# UNITED STATES PATENT AND TRADEMARK OFFICE

APPLICATION NO.	FILING DATE	FIRST NAMED INVENTOR	ATTORNEY DOCKET NO.	CONFIRMATION NO.
10/501,608	11/12/2004	Cornwin Albertus Van Heteren	52998-011400	2266
33717	7590	08/03/2006	EXAMINER	
GREENBERG TRAURIG LLP 2450 COLORADO AVENUE, SUITE 400E SANTA MONICA, CA 90404			RODRIGUEZ, SAUL	
			ART UNIT	PAPER NUMBER
			3681

<b>Office Action Summary</b>	Application No. 10/501,608	Applicant(s) VAN HETEREN ET AL.	
	Examiner Saúl J. Rodríguez	Art Unit 3681

This is a first office action on the merits of patent application S. N. 10/501,608.

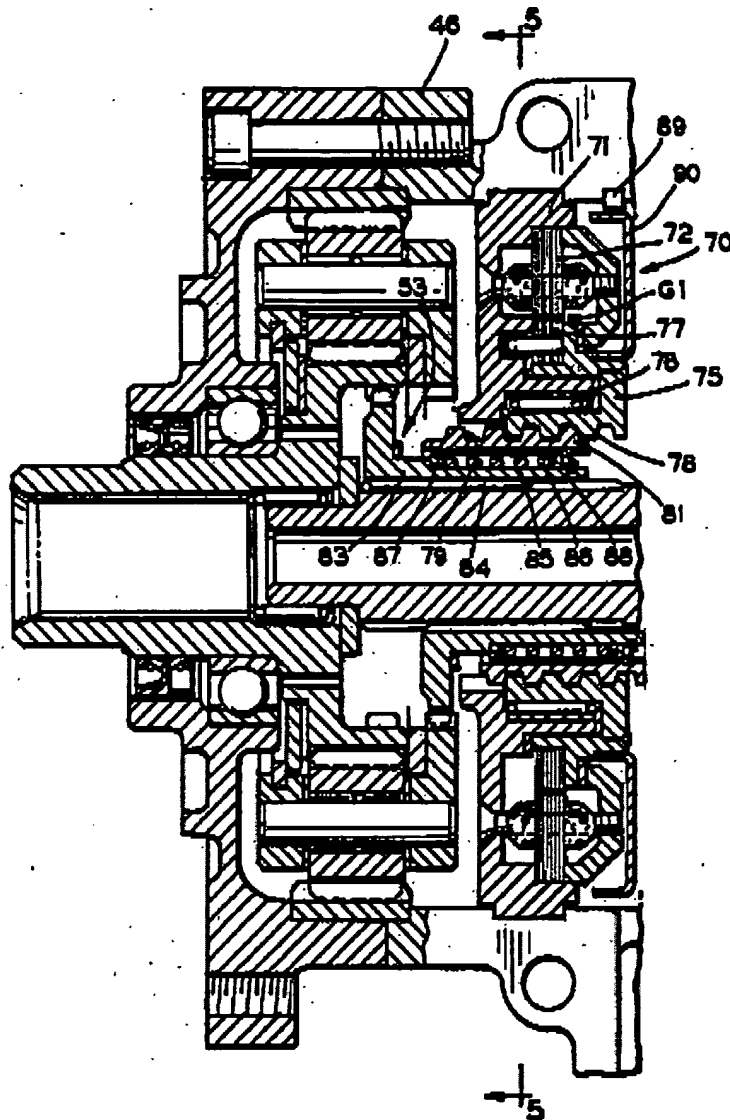
Claims 1-4 and 10-12 are rejected under 35 U.S.C. 103(a) as being unpatentable over Reuter et al. ('325) in view of JP ('063).

Reuter discloses a clutch (Fig. 6) comprising a clutch discs with caliper/clamping means and opposite friction pads (65), ongoing/outgoing members (44, 62), coaxial

**FIG. 4**

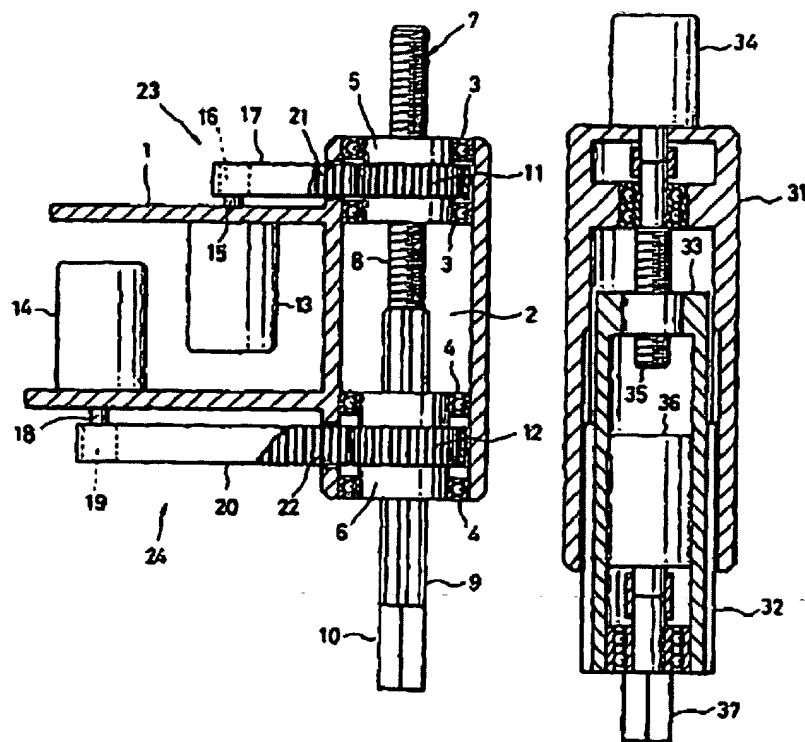
electric motor means (100), screw/nut actuation means (115), a housing, a stator, and a gear drive (111).

Reuter does not show an screw and nut driven by respective motors. It has been known, however, it has known to use two motors are used to rotate separately the ball screw nut and the spline nut in order to obtain two degrees of freedom in rotation and

axial movement. For example, JP discloses a screw/nut actuator having coaxial independent motors for the ball and screw. Then, it would have been obvious to a person of ordinary skill in the art at the time the invention was made to use a pair of motor to drive the actuator of Reuter in view of JP to increase the torque capacity of the actuator.
